**Ltr re our 8-13-71 ltr ..furnishing
addl info(answers to questions 2,3 & 4)
on the partial refueling of Nine Mile
Point reactor..answers to questions**

August 20, 1971

Your letter of August 13, 1971 requested additional information on the partial refueling of the Nine Mile Point reactor scheduled for September 19, 1971. Upon receipt of this letter, Niagara Mohawk immediately initiated the preparation of a response.

FIGURE 4-1

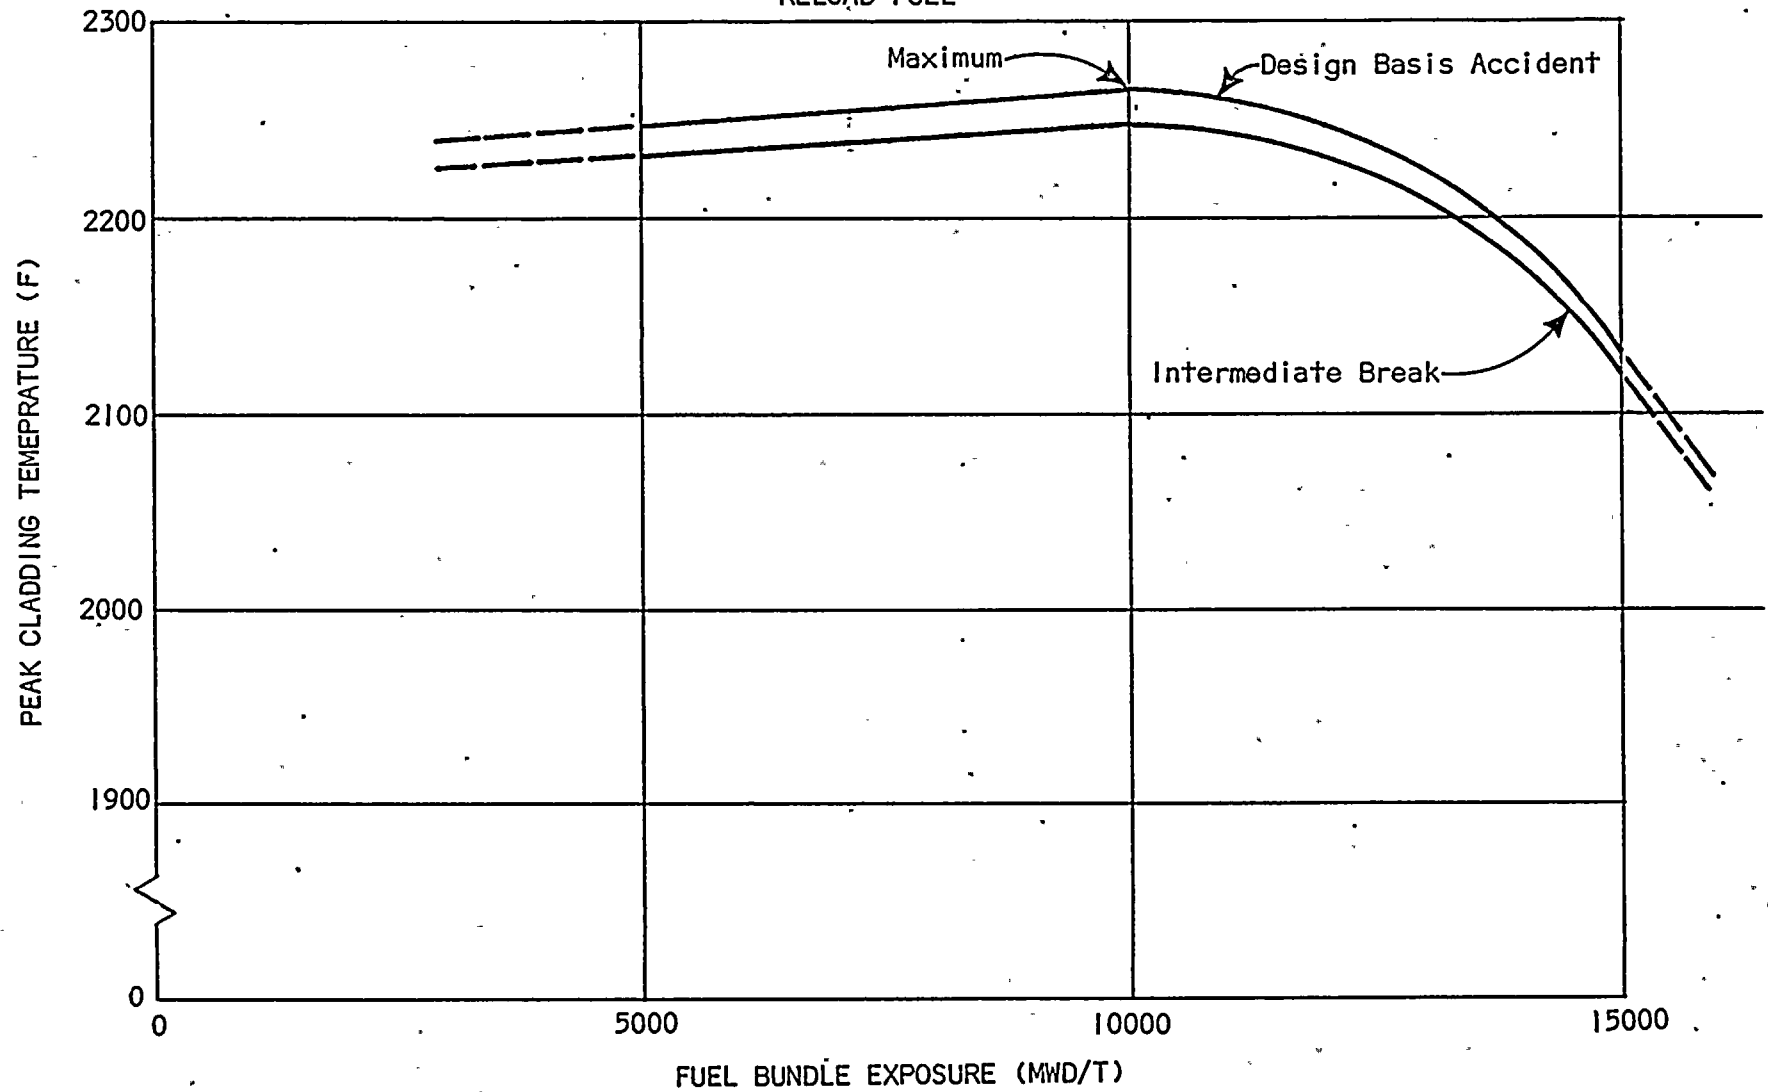
Describe in detail the effect of the proposed fuel on analytical results obtained from the study you are performing in response to our letter to you dated July 22, 1971, concerning the AEC interim acceptance criteria for the performance of emergency core cooling systems.

The same single-failure events described in our letter of August 20, 1971 to the Commission for the initial core fuel were used in the reload analyses and the complete range of peaking factors, from the beginning to the end of bundle life, was studied. Results are shown in Figure 4-1. The maximum peak clad temperature of the reloaded core occurs at 10,000 MWD/T, even though the highest local peaking factor is not then at its maximum. A maximum peak clad temperature of 2265F was obtained from this study for the design basis accident; the corresponding peak clad temperature for the worst case intermediate size break is 2245F. Clad embrittlement continues to be avoided for all breaks up to and including the design basis accident since the maximum local cladding oxidation is less than 7.0% for the reload core case. These data compare closely to those calculated for the initial core bundles. Thus, the Nine Mile Point reloaded core will continue to be in conformance with the Commission's Interim Acceptance Criteria when reload fuel of the type described in our letter of July 27, 1971 is employed at any location in the core.
